**Swimming Pool Audit
for the
City of Oak Ridge, Tennessee**

Counsleman • Hunsaker
AQUATICS FOR LIFE

March - 2016

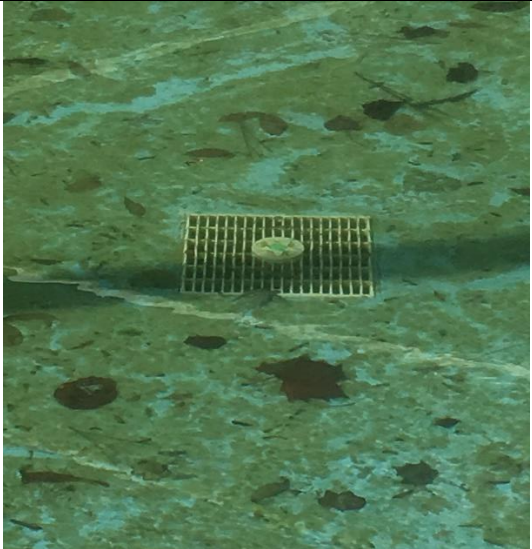
The stainless steel gutter is showing signs of its age. Mild corrosion exists but is to be expected. However, there are areas of the gutter where movement and separation have taken place. It appears there have been attempts to weld the gutter to limit future movement, but gaps have opened limiting the design purpose and effectiveness of the gutter system.

Other than the zero entry area, there is no gutter grating in place. I suspect when the gutter was installed grating was provided for the entire perimeter of the gutter system.

| <p>Where gutter grating does exist, there are numerous locations where the gutter grating is fractured and splintered. There are other areas where the grating is not properly mounted to the gutter making it loose and vulnerable to additional damage.</p> |  |

- a) New gutter grating should be installed on the entire gutter system. Although Tennessee State Health Code does not dictate this requirement, it is highly recommended due to safety concerns.

- b) The stainless steel gutter system needs to be isolated and pressure tested. There are numerous locations where joints have opened and attempts at welding have taken place. It is likely that this process will need to be performed by a representative of the manufacturer.

- c) The bottom of the stainless steel gutter that rest upon the concrete needs to be sealed. This is noted in the “Structure and Finish” portion of this report.

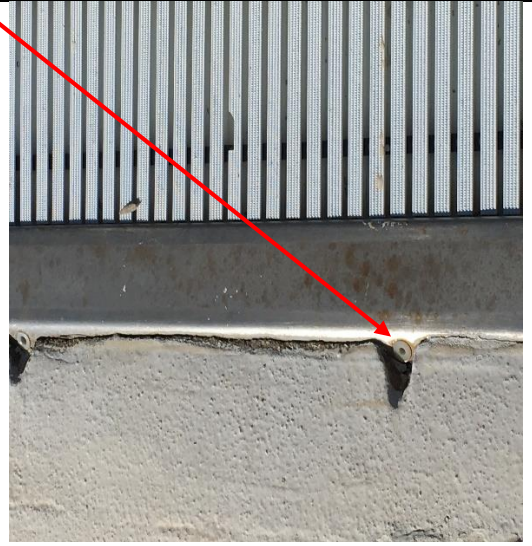
| <p>Main pool utilizes a pressure tube built into the stainless steel gutter system. Filtered and chemical treated water is returned to the pool through this pressure tube roughly 10 to 12” inches below the water surface. The as-built drawings do not indicate any further inlets.</p> <p>It has been noted that the deep water into pool often times becomes cloudy. The lack of filtered water being introduced to the deeper water can contribute to this issue.</p> |  |

- The stainless steel gutter pressure tube and pressure piping needs to be pressure tested to verify there are no obstructions or leaks keeping the recirculation system from functioning as originally designed. If leaks are found they need to be repaired and then retested.

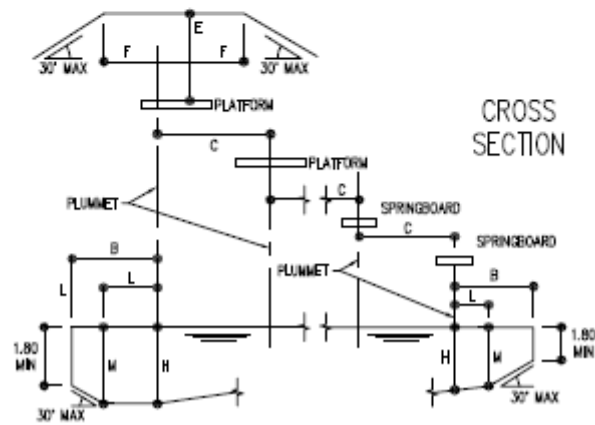
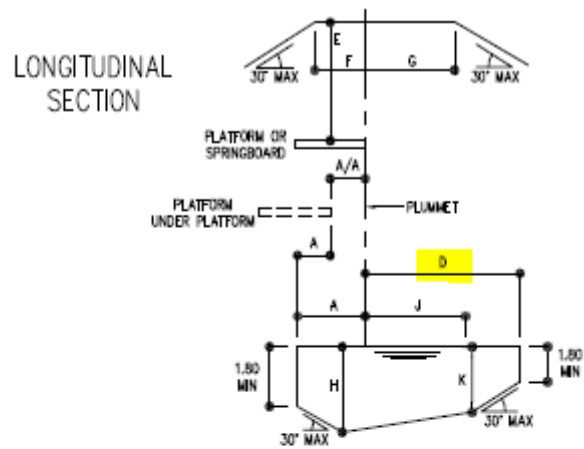
- a) Per current industry standards and national regulatory diving standards, there are portions of the main pool dive area that do not meet required pool slopes for 3 meter diving. Please refer to the charts shown below listing the dimensional national

standards for 1 & 3-meter dive stands. Dimension “D” shown below is noted as 33’-0” per As-built drawings. Regulatory standards require this dimension to be 33’-8”.

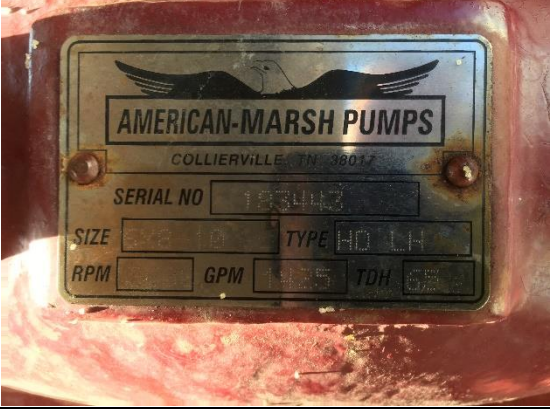
Very little of the pool piping is exposed for observation. It appears all of the pool piping is all Sch. 40 PVC.

Pool staff relayed that they are not certain if the main pool is losing any water due to the water replacement by the natural spring.

- a) Pressure test all pressure and suction pool piping. It is recommended to use a testing method utilizing helium as the tracer gas. To Locate a Leak, pipes are pressurised with helium and the operator uses a Sniffer Probe connected to the inlet of the leak detector. If the pipes lose pressure the probe is inserted into the soil at or near the underground pipe locations pinpointing the location of the leak.
- b) If piping leaks are found it is imperative that they are repaired and that the piping is re-tested to assure that all leaks are addressed. Excessive loss of water can result in undermining of the pool structure and/or surrounding decks. Additionally, chemical costs can spiral out of control.

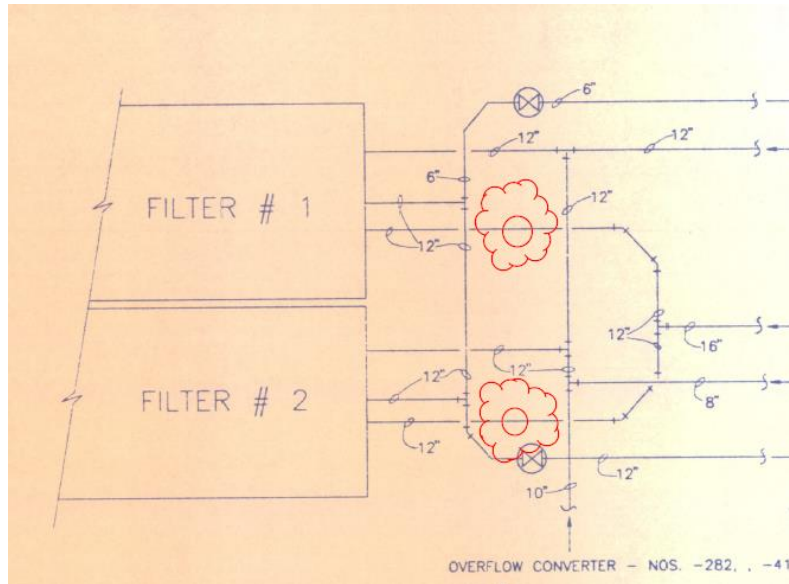
| <p>Many of the filtration valves are difficult to operate or move too freely resulting in the uncertainty of proper operation. This can result in improper filtration or backwash operation.</p> |  |
| <p>Currently the filters cannot be isolated in the event of needed maintenance due to the lack of isolation valves.</p> |  |

- a) It is recommended to replace “all” filtration and backwash valving for all 4 filter systems. This includes the addition of “isolation” valves as clouded blow. The isolation valves will allow bypass of a particular filter for maintenance purposes.

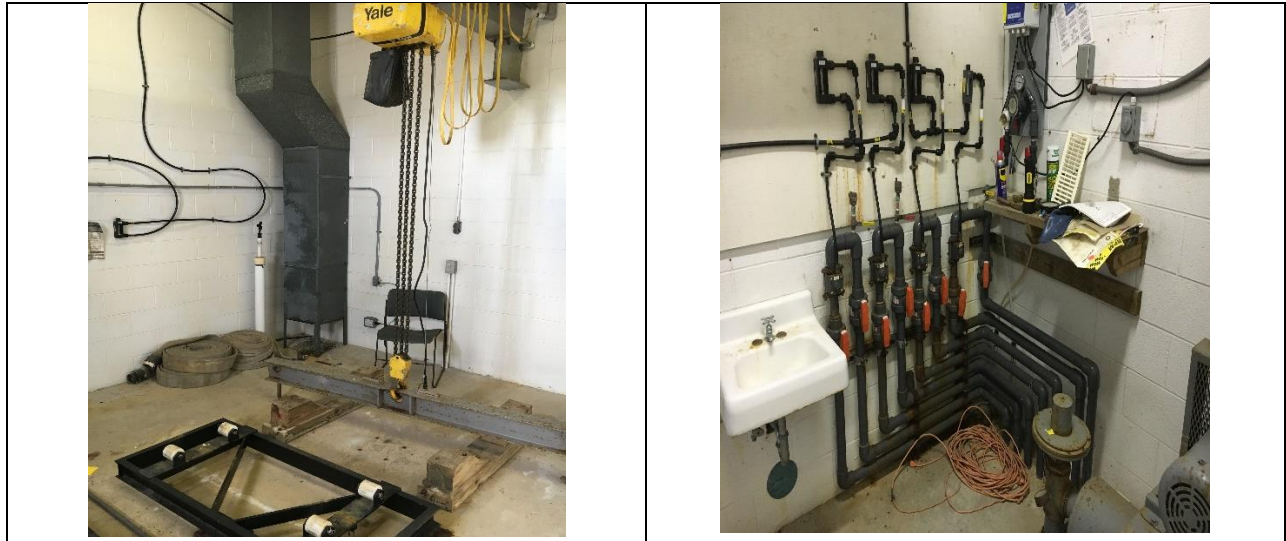
The current chemical treatment system is chlorine gas. While it is acceptable per Tennessee State Health Code, it is a very dangerous chemical and not recommended by Counsilman Hunsaker.

The chemical controller should have a “y” strainer on the intake side of the flow cell. This keeps particulate from obstructing the flow cell operation.

- a) It is highly recommended to replace the chlorine gas system with a sodium hypochlorite system. This will eliminate the potential hazards of working with such a volatile chemical creating a safer work environment for pool employees. However, I understand that the chemical cost increase would be significant.
- b) Pool staff reported a dramatic increase in chemical usage over the past 2 or three years. This can be contributed to a number of issues. However, typically we see chemical numbers jump when the pool is losing water. By testing the pool piping and gutter systems we can pinpoint a potential cause to the increased chemical usage.
- c) Install “Y” Strainers on the intake line prior to the flow cell on each chemical controller.

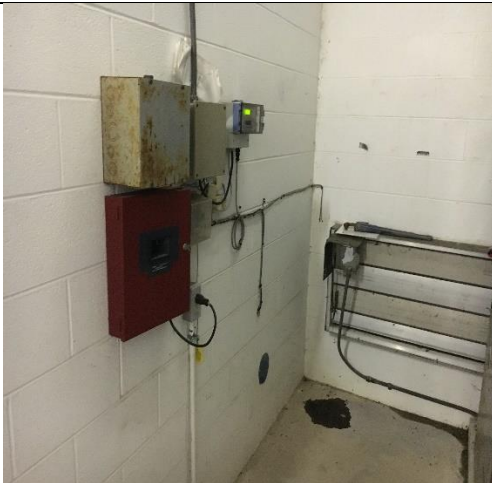
The two separate mechanical spaces house the chemical feeders, chemical controllers and the acid feed systems. Electrical panels and all metal components show minimum corrosion.

A ventilation fan was not present. However, both mechanical spaces appear to be in good condition with minimal corrosion.

- a) Exhaust fans are recommended for these rooms to remove chemical fumes and moisture.
